addendum

No.	01	**Project:**	WCFPD Station 1
Date:	September 16, 2025	**Project No:**	025-2125

Modifications to Construction Drawings:

1 A301 BUILDING SECTION 1
3/32" = 1'-0"

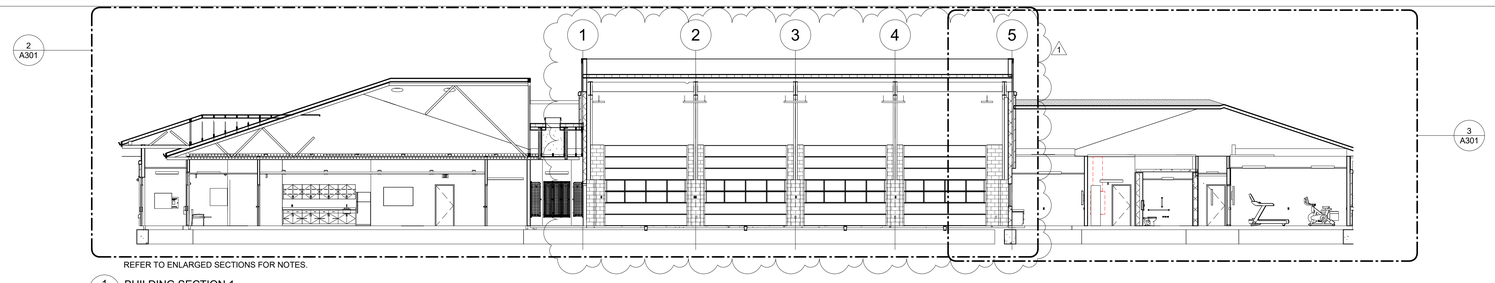
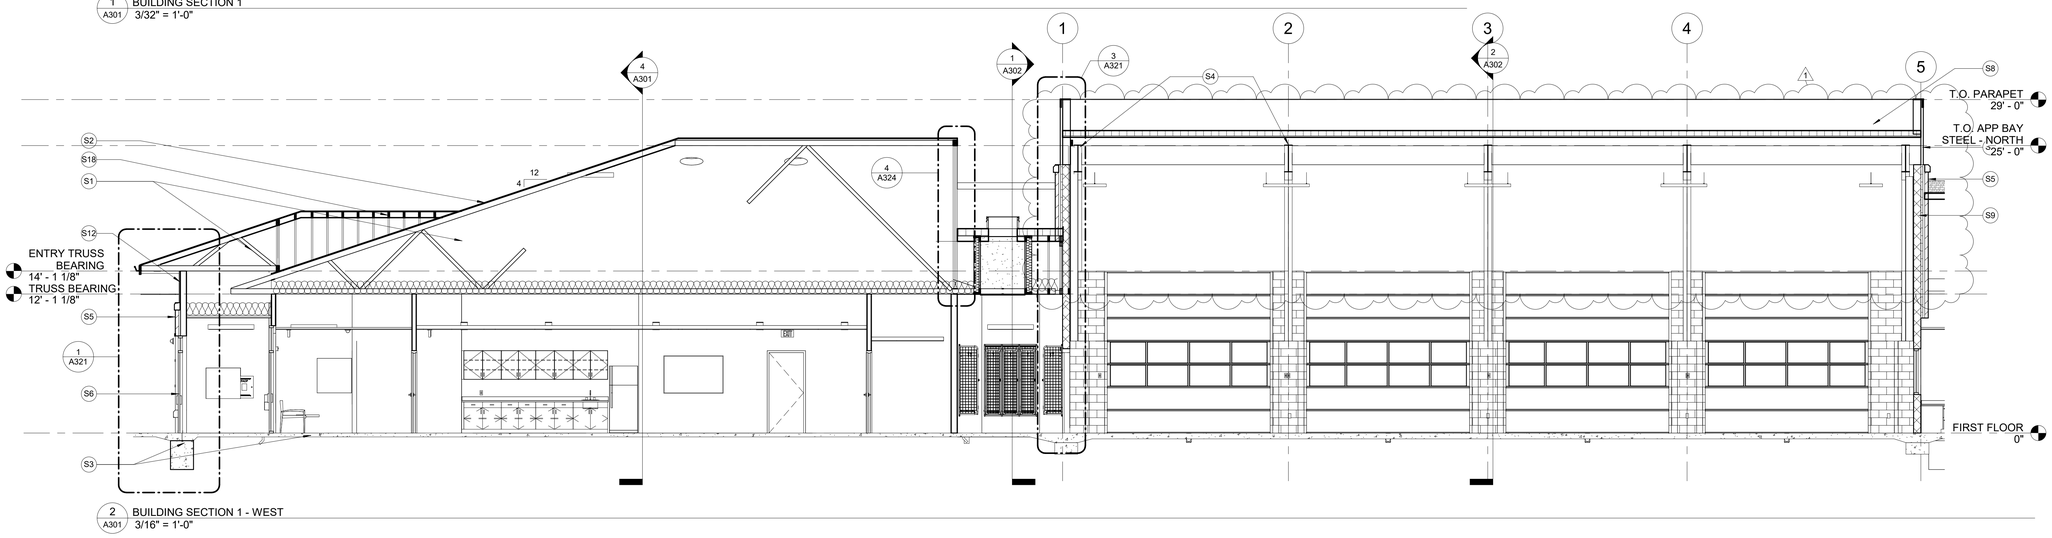
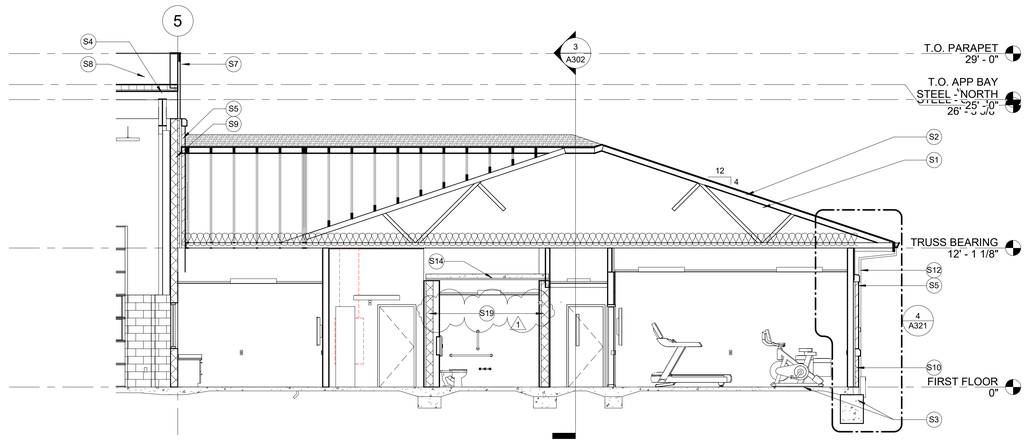
a. MODIFY 1/A301 and 2/A301 to accurately reflect the height of the CMU.
    b. ADD note S19 and added in 3/A301.
16) Sheet A302 – BUILDING SECTIONS
    a. ADD Building Section General Notes And Keyed Notes – Building Sections.

1 WALL SECTION A322 3/4" = 1'-0"

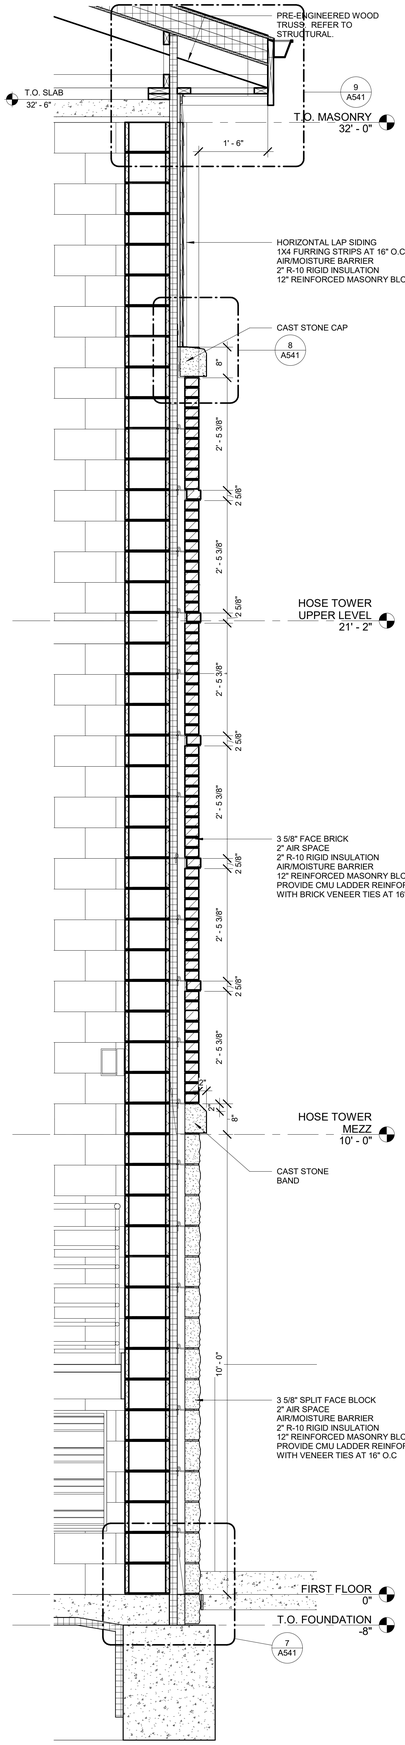
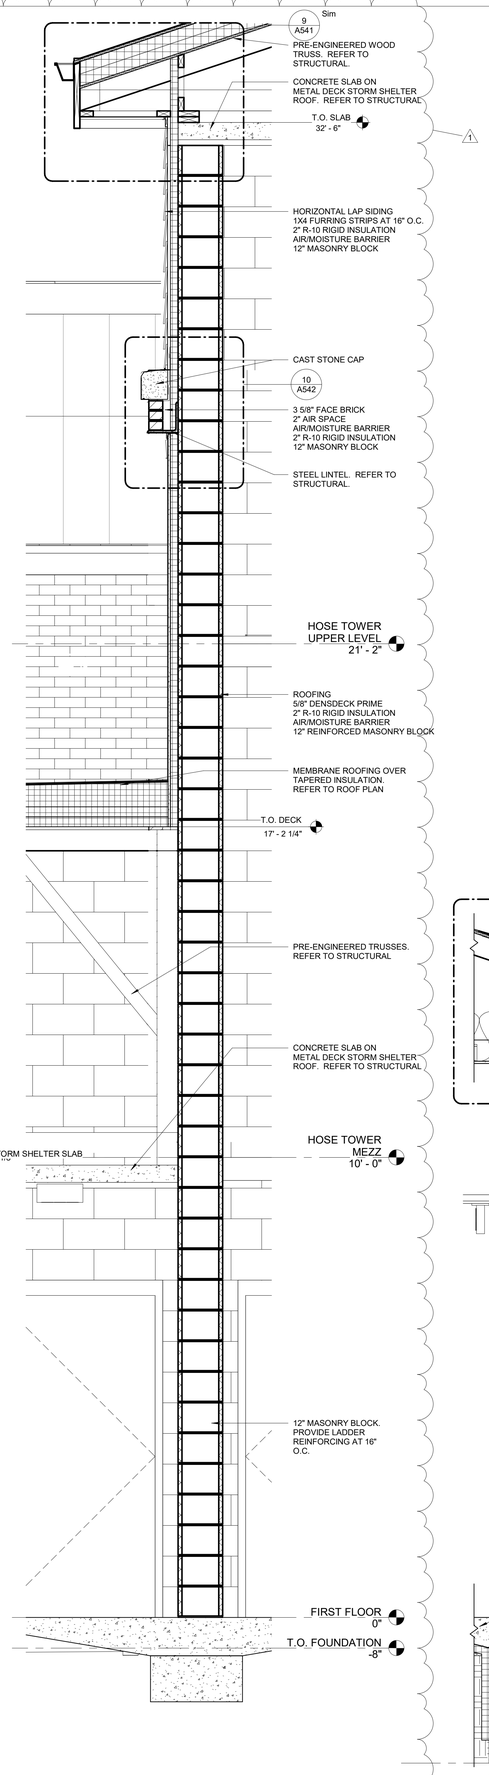
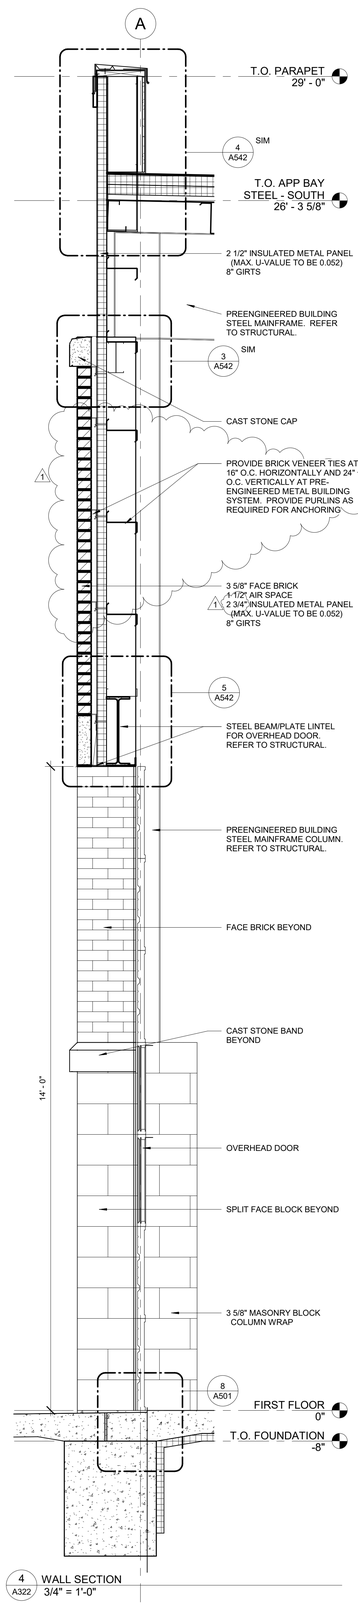
17) Sheet A321 – WALL SECTIONS
    a. ADD general note to sheet.
18) Sheet A322 – WALL SECTIONS
    a. ADD general note to sheet.
    b. MODIFY Wall Sections 1/A322, 2/A322 and 4/A322.

3 A323 WALL SECTION 3/4" = 1'-0"

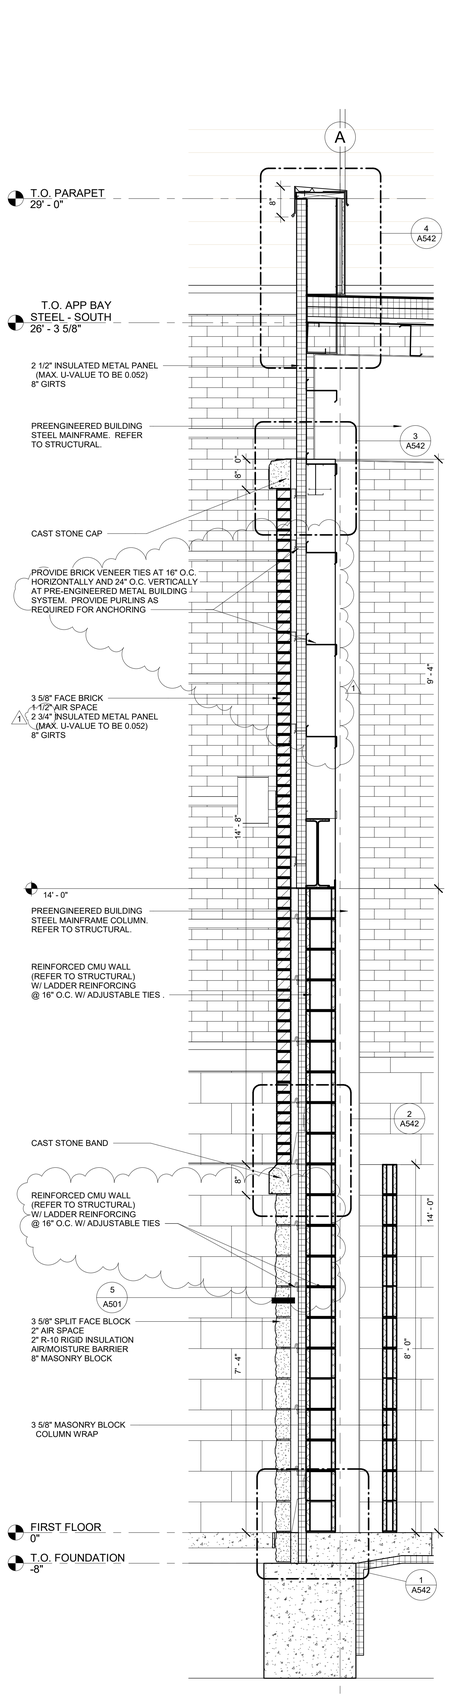
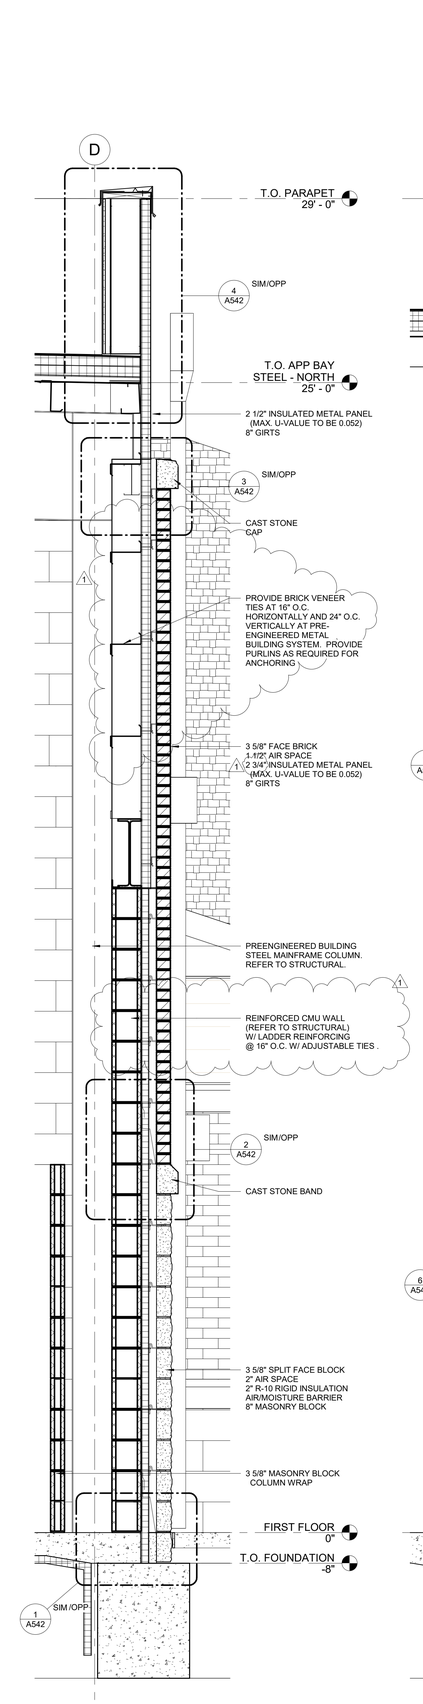
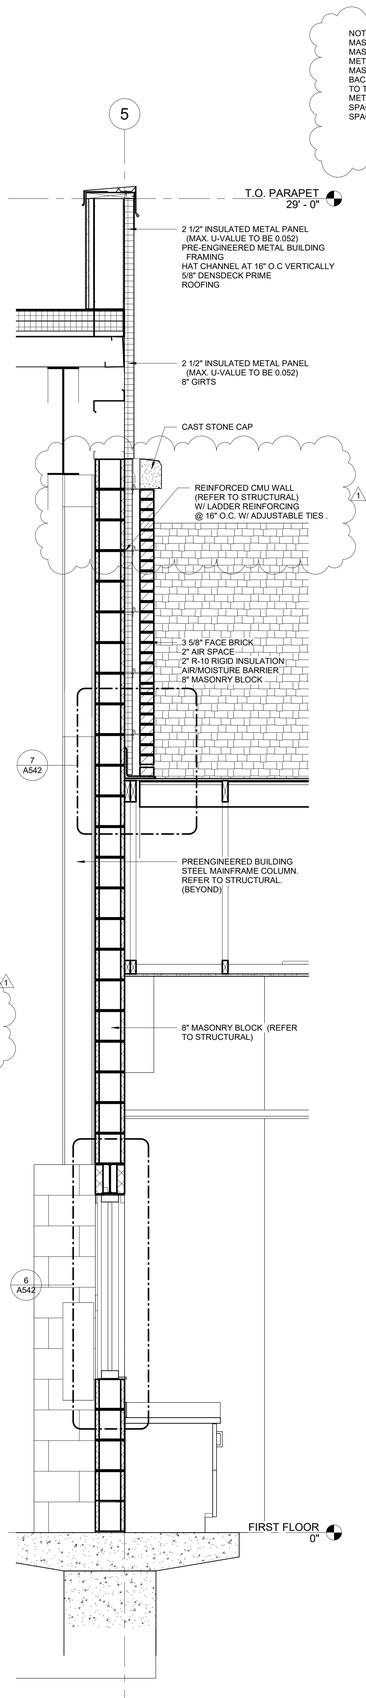
19) Sheet A323 WALL SECTIONS
    a. ADD general note to sheet.
    b. MODIFY Wall Sections 3/A323, 4/A323, 5/A323.
20) Sheet A324 – WALL SECTIONS
    a. REVISE Wall Section 1/A324 to wood stud framing in lieu of concrete block.

1 A324 WALL SECTION
3/4" = 1'-0"

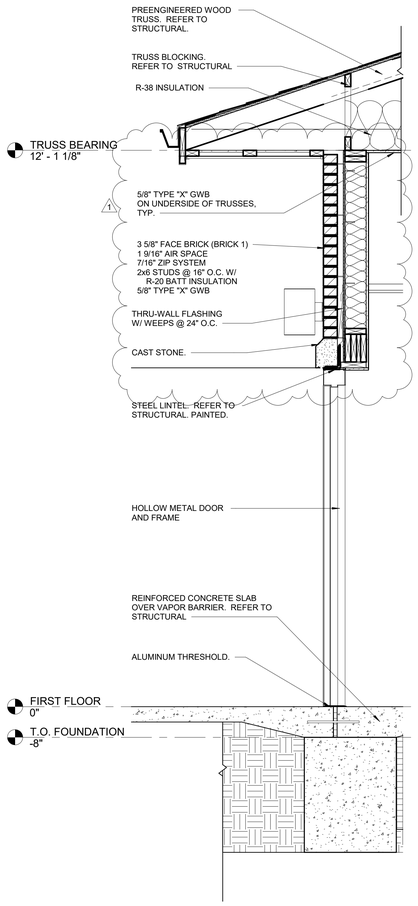
d. REVISE size of door 133A to be 3'-6".
   e. REVISE Partition Type at Room 120 and 121.
   f. ADD remote access control of Door 101 in Office 102.
   g. REVISE the North wall of Passage 129 to wood stud framing in lieu of concrete block. Refer to wall Section 1/A324.

3 A541 SECTION DETAIL
1 1/2" = 1'-0"

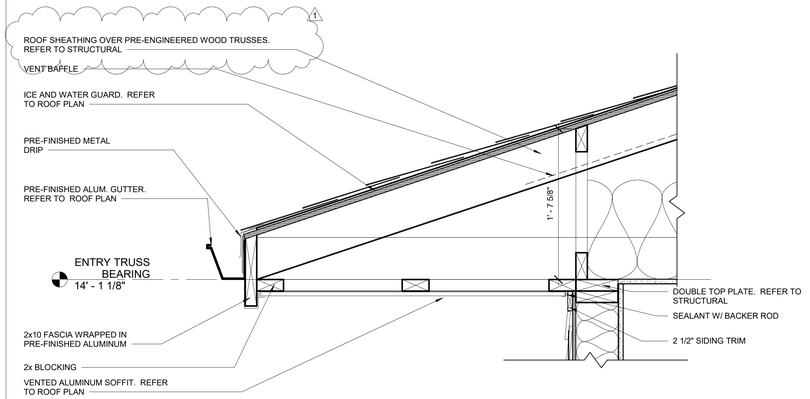
22) Sheet A541 – SECTION DETAILS
    a. REVISE Section Details 3/A541 & 9/A541
23) Sheet A542 – SECTION DETAILS
    a. REVISE detail 5/A542, 7/A542, 12/A542, 113/A542, and 14/A542.

1 A603 PARTIAL EQUIPMENT PLAN - WEST
3/16" = 1'-0"

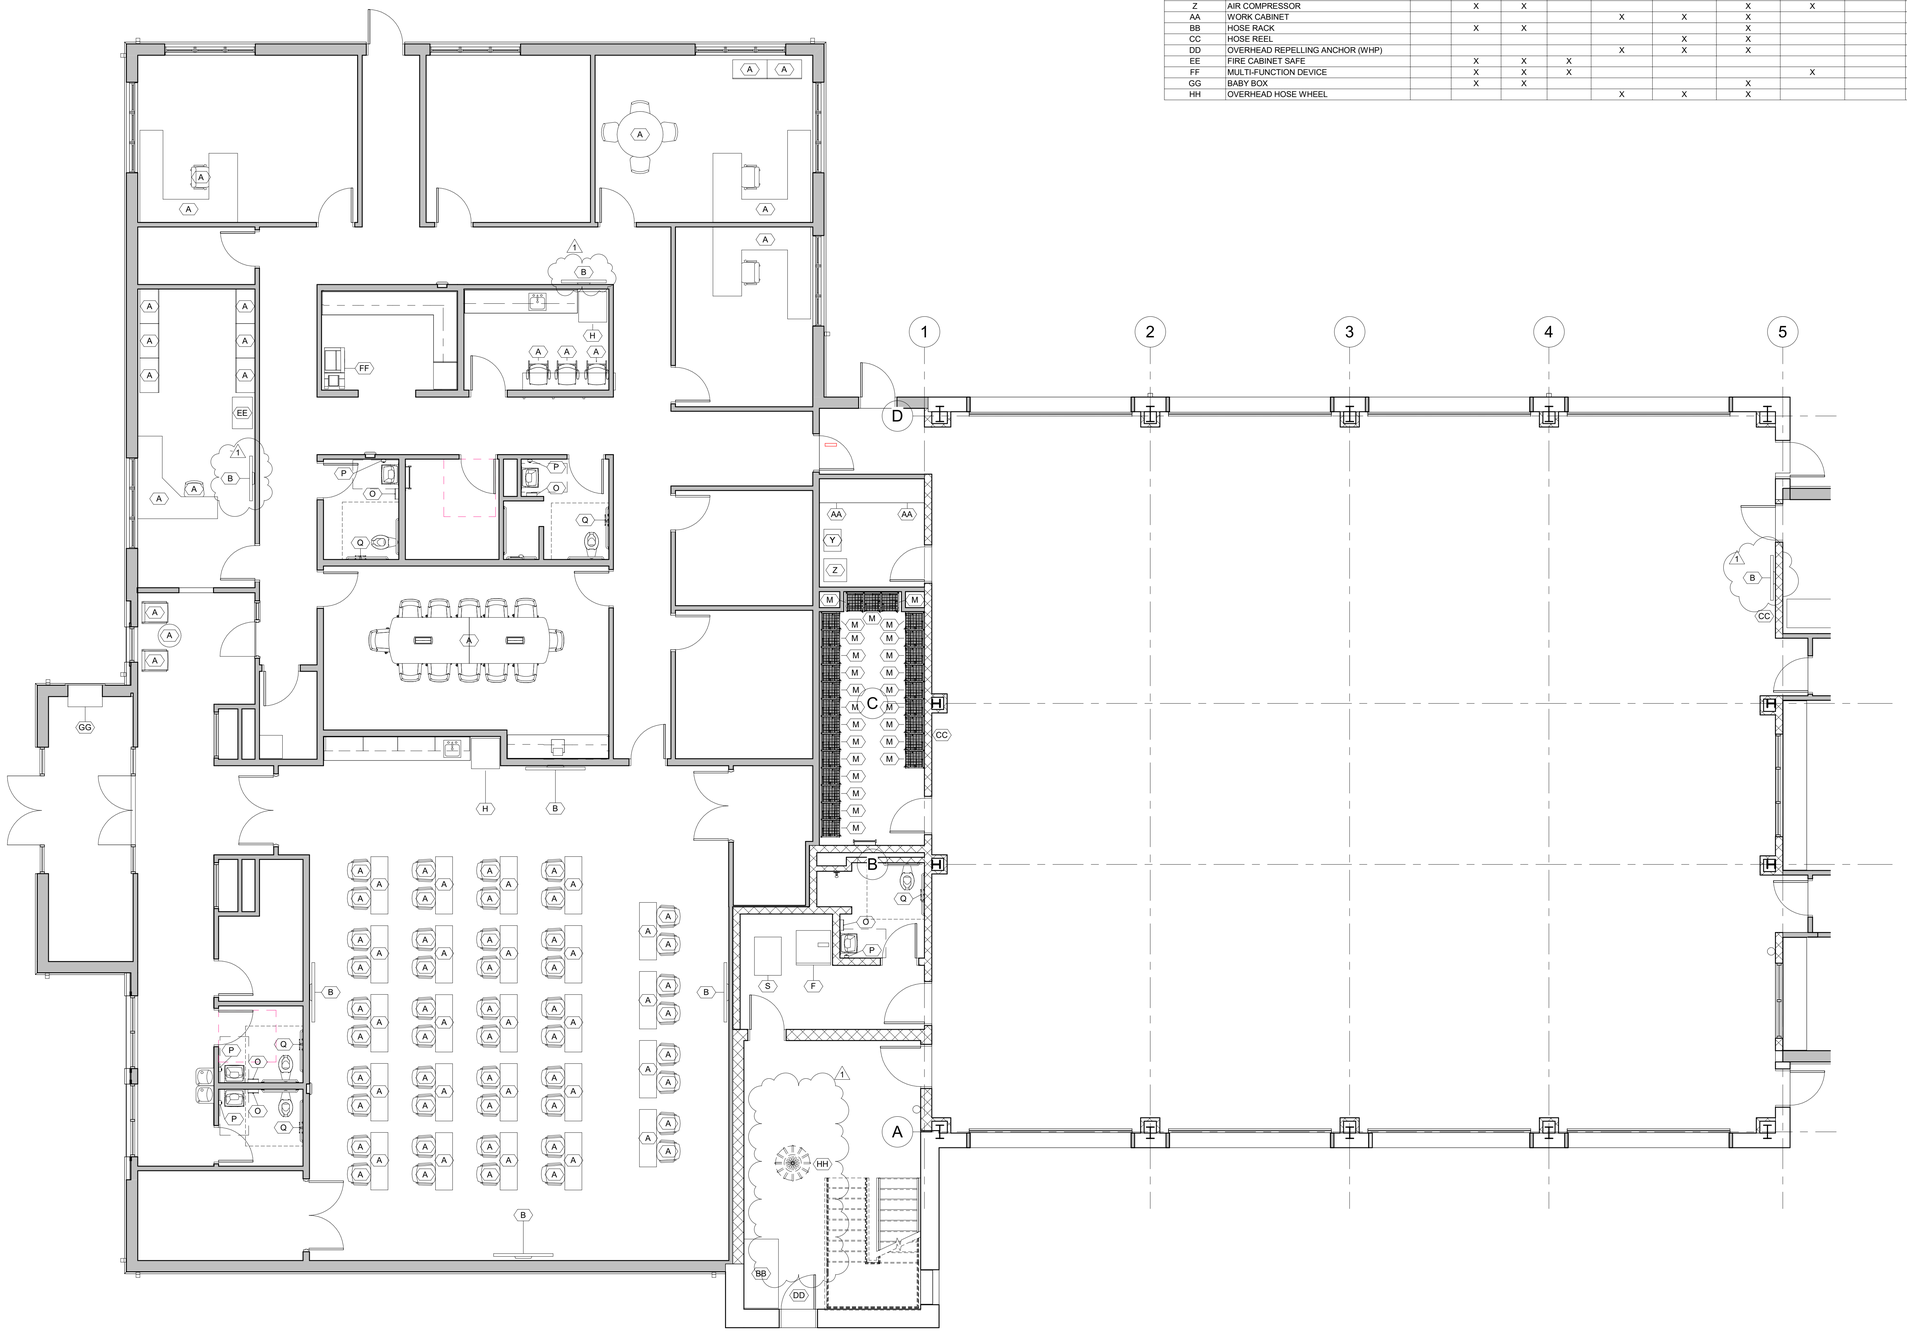
26) Sheet A603 – PARTIAL EQUIPMENT PLAN (WEST) AND SCHEDULE
    a. MODIFIED number of hose wheels in the Hose Tower.
    b. ADD TV locations.
27) Sheet A604 – PARTIAL EQUIPMENT PLAN (EAST) AND SCHEDULE

1 A604 PARTIAL EQUIPMENT PLAN - EAST
3/16" = 1'-0"

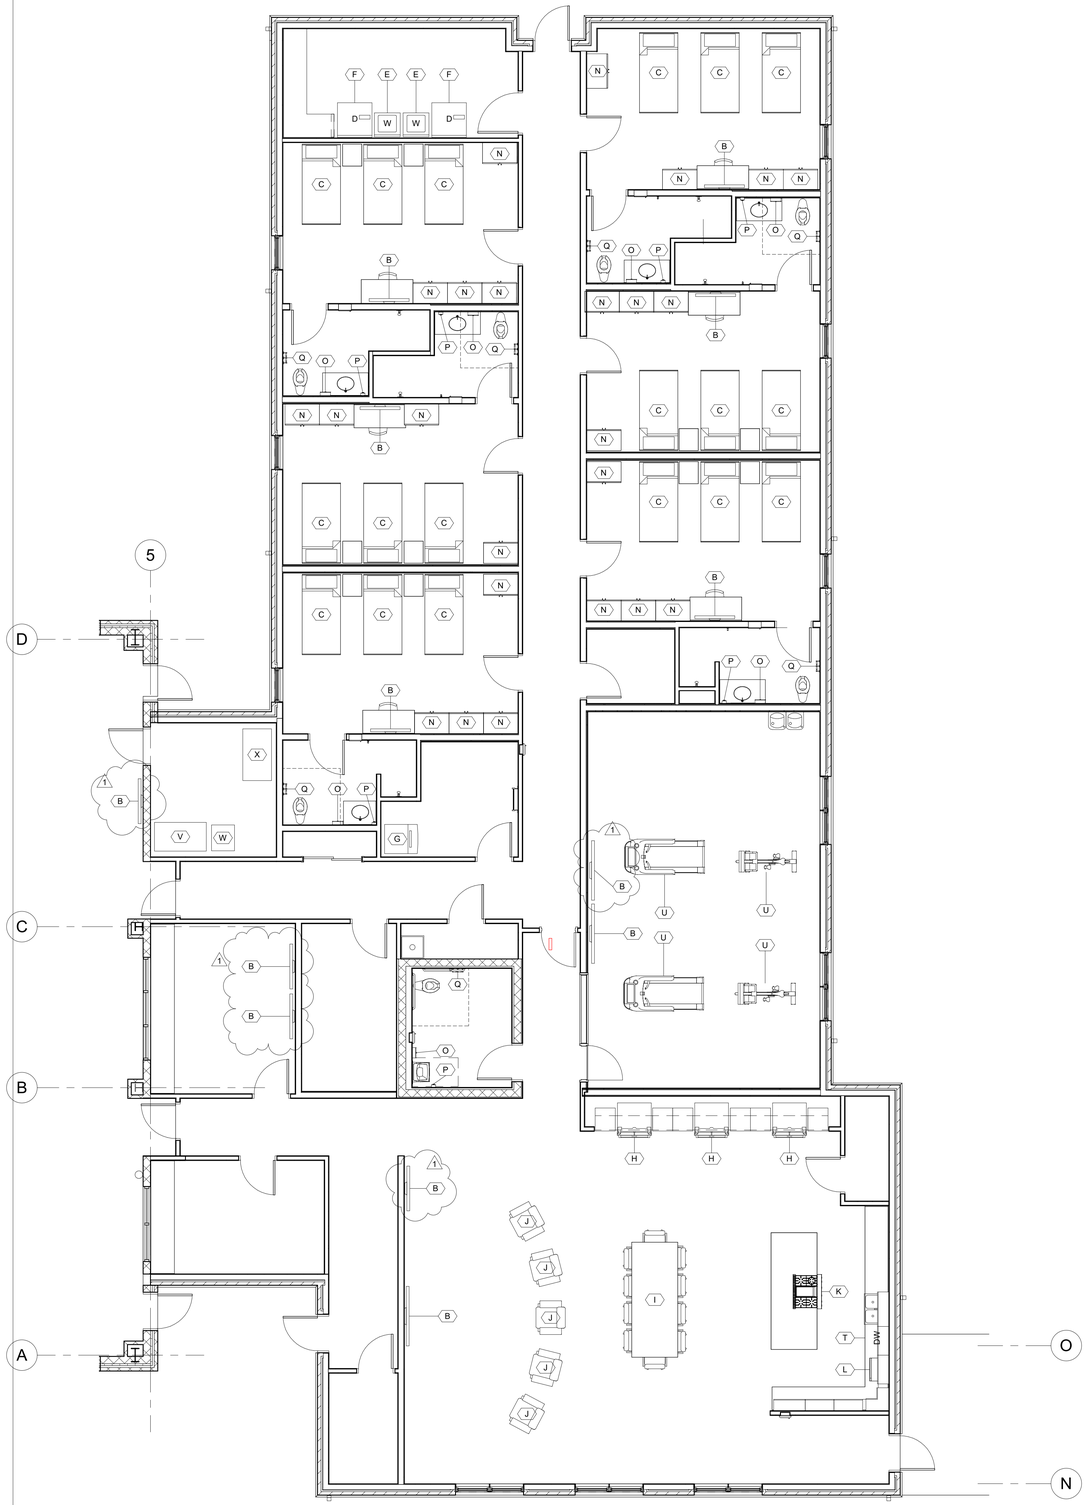
a. ADD TV locations.
28) Sheet A961 – PARTIAL ROOM FINISH PLAN (WEST) AND LEGEND
    a. REVISE Meeting Room 123 flooring to LVP-2.
29) Sheet S200 – FOUNDATION PLAN
